PLANNING BOARD AGENDA

V. CONTINUED FORMAL VARIANCE APPLICATION
ROME, ELAN S, TRUSTEE OF THE ELAN ROME LIVING TRUST
(CONTRACTOR CHRIS MOTT BUILDERS)
407 17TH AVENUE
BLK - 6 LOT - 36

**Re: Completeness/Technical Review #2
407 17th Avenue (Mott)
Block 6, Lot 36
H2M Project No. LKCP 2103**

**ZONING REVIEW for Walker Residence, 407 Seventeenth Avenue, Lake Como
(Revised 2/12/2021 and again on 3/29/2021)**

FIRST FLOOR PLAN
 SCALE: 1/4" = 1'-0"

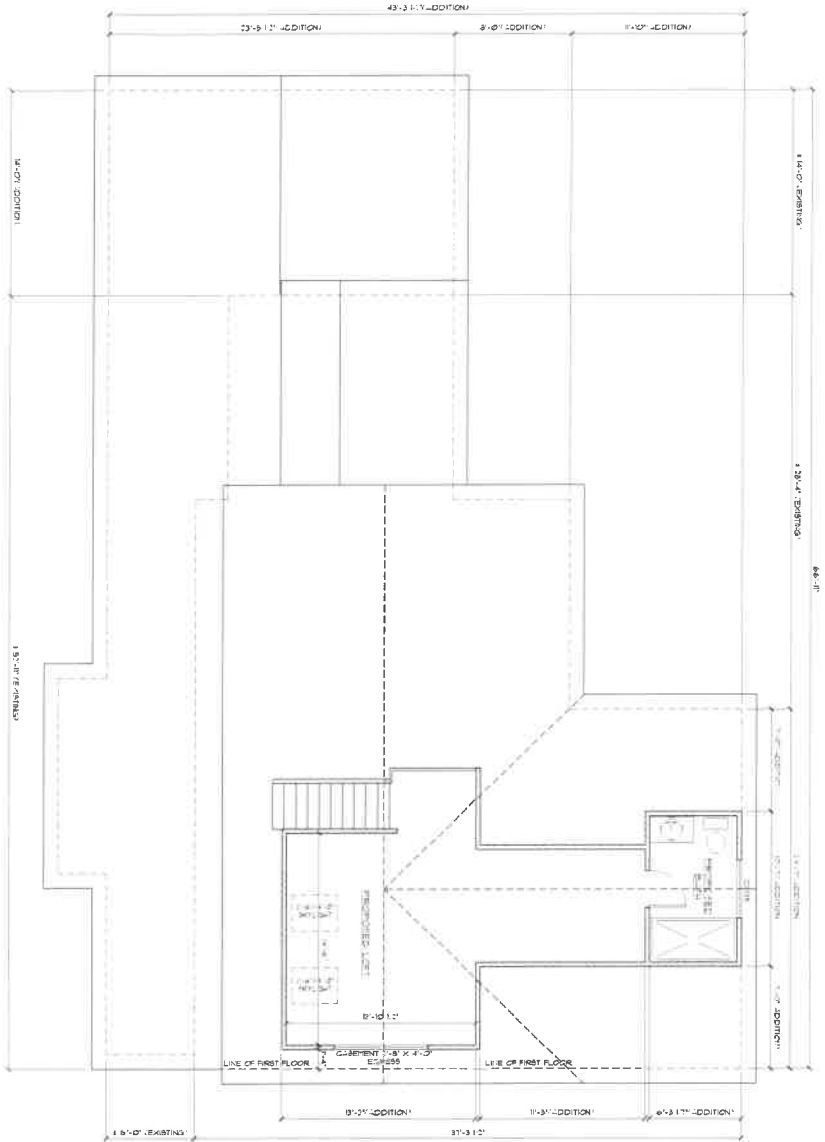
6. **The survey and floor plans provided show a Bilco Door on the Wooley Lane side of the existing dwelling; however, this feature is not depicted on the Site Plan, and will likely conflict with the proposed paved walk. The Applicant should provide testimony regarding this issue.**
7. **The Artist Rendering on Sheet Z-1 of the amended architectural plans depicts some sort of superstructure over the proposed patio while the "Site Plan" on the same sheet identifies a proposed outdoor grill area without any sort of superstructure. The Board should elicit testimony regarding this discrepancy and consider any further relief necessary in the event the Applicant is proposing said superstructure.**

SECOND FLOOR PLAN
SCALE: 1/4" = 1'-0"

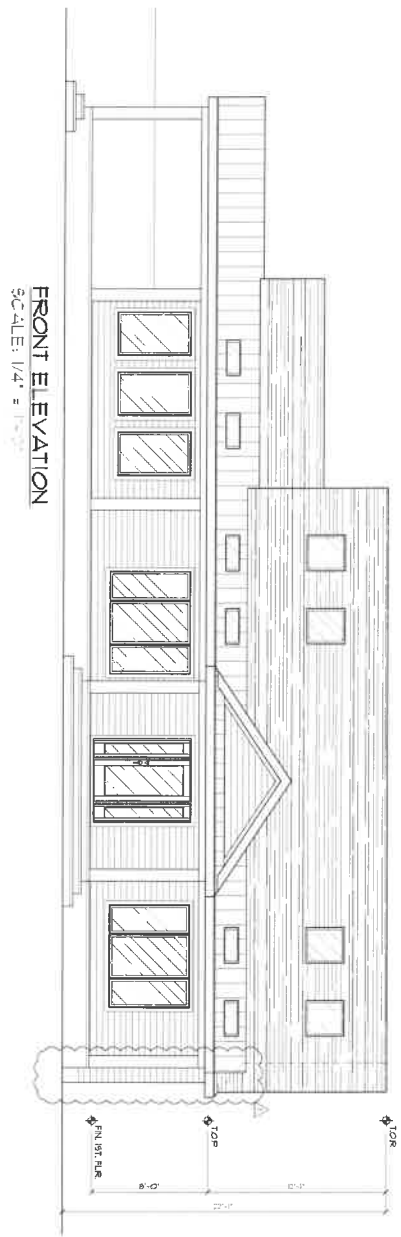
1. The front porch will be set-in on the west side of the house to conform to a 3.1' side setback.
2. The proposed bedroom window on the west side of the house will be removed and the existing will remain at the rear.
